NUREG-1437, Vol. 1
Addendum 1

Generic Environmental Impact Statement for License Renewal of Nuclear Plants

Main Report
Section 6.3—Transportation
Table 9.1 Summary of findings on NEPA issues for license renewal of nuclear power plants

Final Report

Figure A.2. Routes analyzed in this study. 1 = from the northeast through downtown (I-15 to 95), 2 = from south through downtown (I-15 to 95), 3 = from the northeast using the Beltway (I-15 to I-215 to 95), 4 = from the south using the Beltway (I-15 to I-215 to 95).

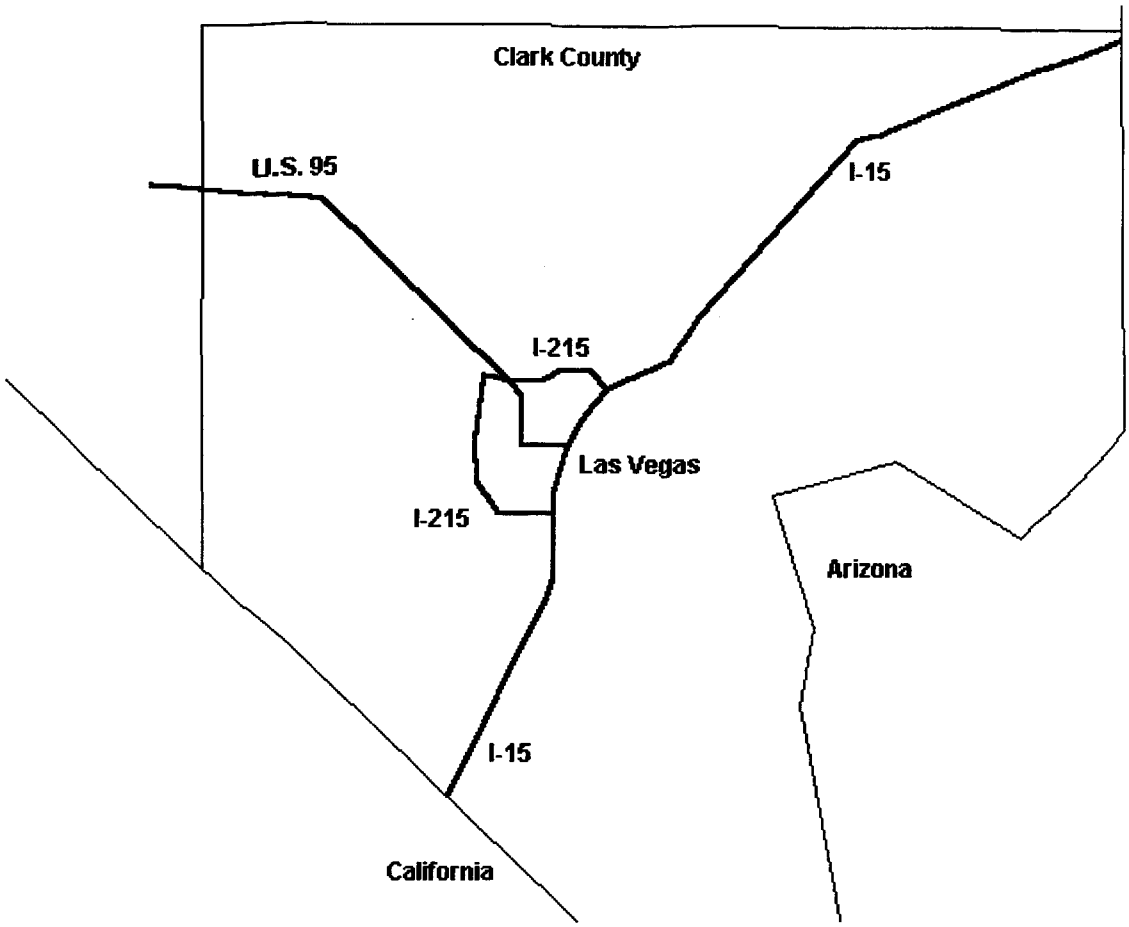
Comment: Addendum 1 assumes that truck transport would have the highest doses. This assumption is not necessarily valid. Also, a different route that avoids Las Vegas should be addressed. (A route through Nellis Air Force Base and down US-95 is being considered by DOE and it has been shown to have higher risks of accident fatalities and to increase the radiological risk.) Routes chosen in Addendum 1 do not bound the analysis properly.

Comment: The study area is inaccurately defined and the location of some cities is incorrectly stated.

Response: The transportation and route scenarios and their underlying assumptions were designed to reflect situations that most likely would result in highest doses in order to bound the analysis properly as the routes chosen for this analysis were the most populated routes in the state of Nevada. Also, as noted in an earlier response, the NRC staff consulted DOE in determining that truck shipments through densely populated areas of Clark County, Nevada, would have the highest potential impacts among the alternative transportation scenarios that would be given serious consideration in decisions relating to the suitability of the site undergoing study for a repository at Yucca Mountain.

The comment that a route from Nellis Air Force Base down US-95 is higher risk than those selected by the NRC staff provided no specific details concerning that assertion. In the NRC staff's view, any route that bypasses major centers of population will have significantly lower radiological impacts. With regard to traffic accident rates, while it may be true that certain routes will have accident rates that are higher than average, the average rates are low enough that modest increases from the average will not significantly change the staff's conclusions.

Response: During the preparation of Addendum 1, the initial study area selected for analysis emphasized the urban areas in and near Las Vegas. Route selections were based in part on their proximity to those areas, not to county borders. However, in response to public comments, the study area was expanded to include the entire county. Consequently, the "entry" point for SNF shipments shifted to cities such as Mesquite.
